PRELIMINARY SITE PLAN
WALTON CREEK
 LAND LOT #17, 16TH DISTRICT, 2ND SECTION
 COBB COUNTY, GEORGIA
 PREPARED FOR
 MAXINE LONG MINCHEW REVOCABLE LIVING TRUST
 DATE: OCTOBER 3, 2012

**Z-52
 (2012)**

ZONING COMMENTS:

Z-52 MAXINE LONG MINCHEW REVOCABLE LIVING TRUST

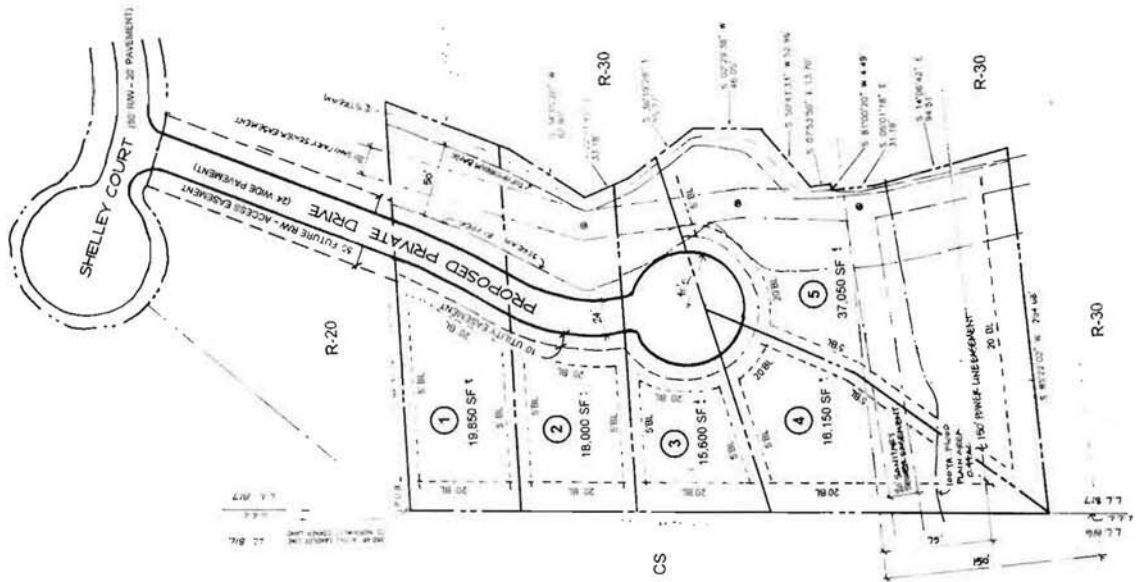
1. Waive the front setback from the required 35 feet to 20 feet; and
2. Waive the side setbacks from the required 10 feet to 5 feet with a minimum of 15 feet between buildings.

HYDRANT: Show fire hydrants arranged to have a hydrant available for the distribution of hose to any portion of any building on premises at distances not exceeding 500 feet (driving distance). Hydrants shall be at least 40 feet from the building (steamer connection facing street) (NFPA 24-7.2.3). Fire hydrants shall be spaced not more than 500 feet apart. Hydrants shall not be connected to water lines on the positive side (discharge side) of a fire pump. Minimum 8” supply lines to all hydrants.

GUEST PARKING: When projects contemplate less than 20 foot separation between units, guest parking shall be provided or the streets shall be labeled as a fire lane.

- No Stormwater controls shown - must be addressed at Plan Review.
- Copy of survey is not current – Additional comments may be forthcoming when current site conditions are exposed.
- No site improvements showing on exhibit.

1. This site is located adjacent to and impacted by the floodplain of Sewell Mill Creek to the south and a small unnamed tributary that forms the eastern property boundary. The proposed private drive is located outside the 50-foot stream buffer, but partially within the 75-foot impervious setback. The drive will need to be shifted to the west or a buffer variance obtained that provides mitigation for this impact.
2. The proposed site plan does not provide space allocation for a stormwater management facility. The proximity to Sewell Mill Creek and its sizable drainage area would qualify the site for fee-in-lieu of detention if a “no impact” analysis can provide proper justification. If an onsite detention pond is required maintenance access must provided from a public R/W and at least one lot would be lost..

Recommend curb and gutter along both sides and sidewalk along one side of proposed development roadway.

Recommend if streets are private then be constructed to the Cobb County Standard Specifications.

Recommend providing an access easement to remaining tract of land.

- Site plan received by the Zoning Division on October 4, 2012, with the District Commissioner approving minor modifications;
- Fire Department comments and recommendations;
- Water and Sewer comments and recommendations;
- Stormwater Management comments and recommendations; and
- DOT comments and recommendations.
